**ADDENDUM NO. 1
TO BID DOCUMENTS
FOR GULF BOULEVARD-PHASE 4, HIBISCUS STREET AND OLEANDER STREET
IMPROVEMENTS
CITY OF SOUTH PADRE ISLAND, TEXAS**

***GULF BOULEVARD-PHASE 4,
HIBISCUS STREET AND
OLEANDER STREET
IMPROVEMENTS***

TRAFFIC CONTROL PLAN

GULF BLVD IMPROVEMENTS

PARALLEL PARKING BAY DETAILS

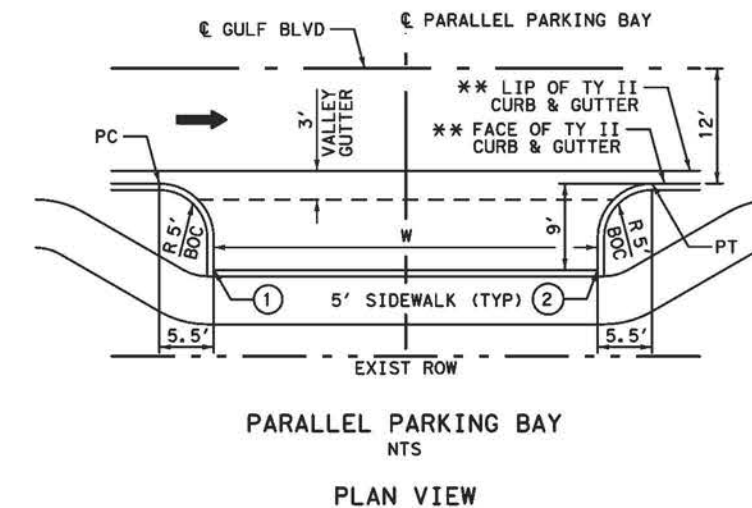
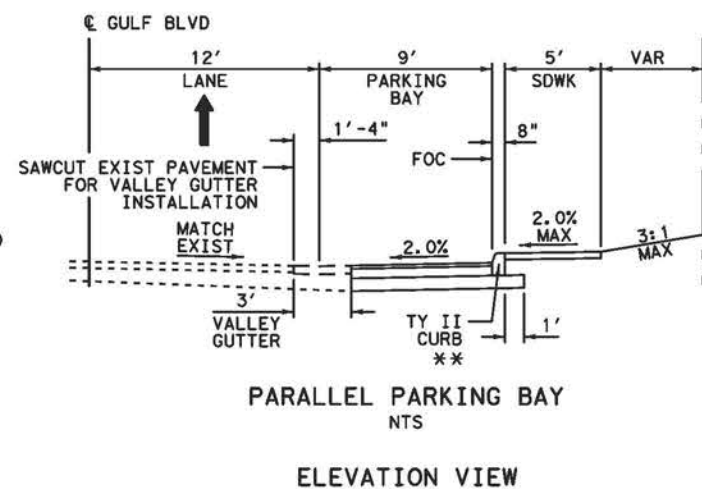
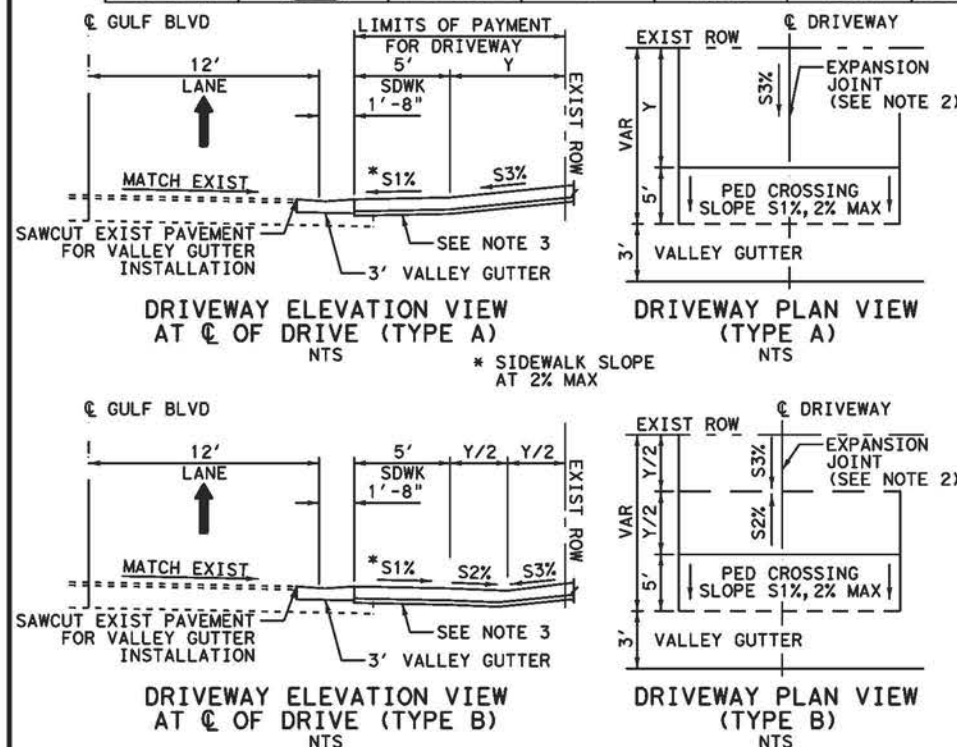
1. **Cover Sheet:** revised City's telephone number
2. **Proposal:** revised bid form as follows:
 - a. Added to Gulf Bid Item 53 "Temporary Markings (Tabs or Buttons) Between Construction Phases"
 - b. Modified Gulf Item 22 "Clearing, Grubbing, and Finishing Slopes" to be Item 23 "Clearing and Grubbing" and added Item 54 "Backfilling Curbs and Finishing Slopes"
 - c. Added Items for brick paver driveways and stamped concrete driveways
3. **Plans:**
 - a. Revised Sheet 6 Traffic Control Plan
 - b. Revised Driveway Tables on Sheets 40, 64, and 72 to add brick paver and/or stamped concrete driveways

REVISED DRIVEWAY TYPE

DRIVEWAY SUMMARY

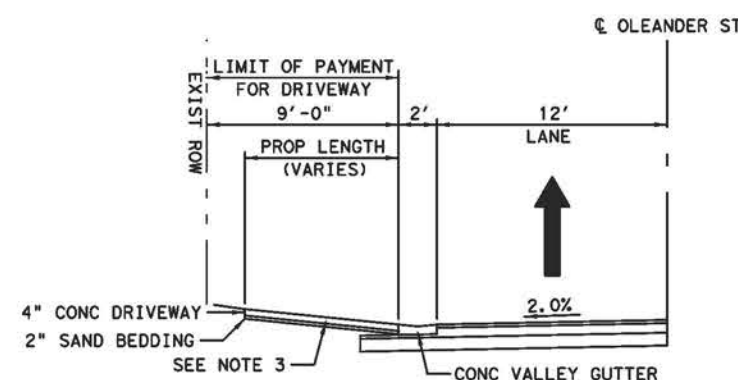
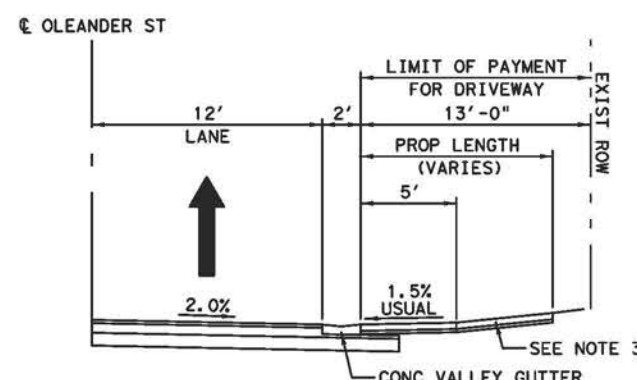
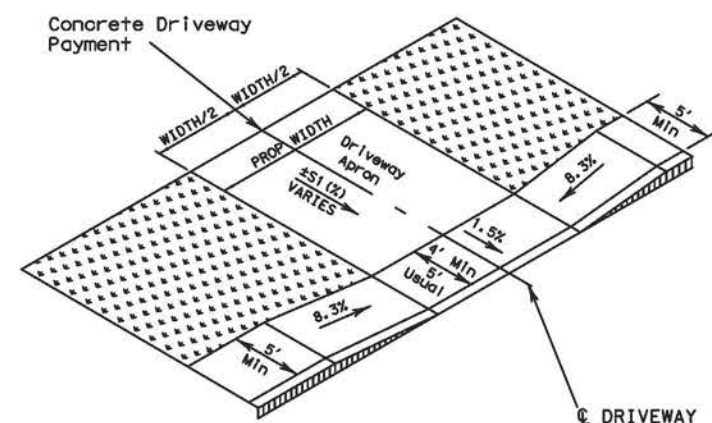
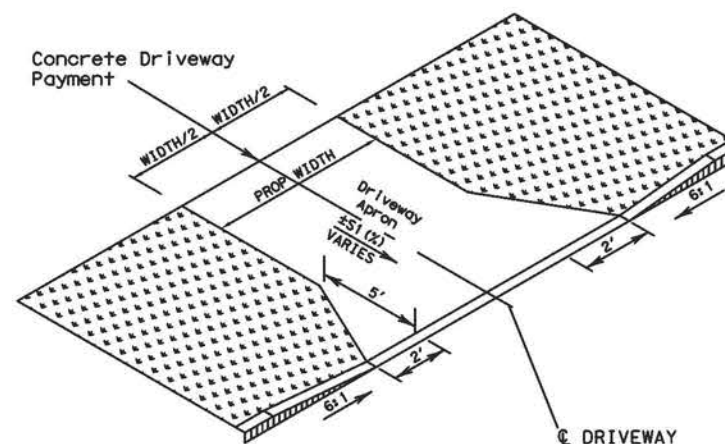
REVISD DRIVEWAY TYPE
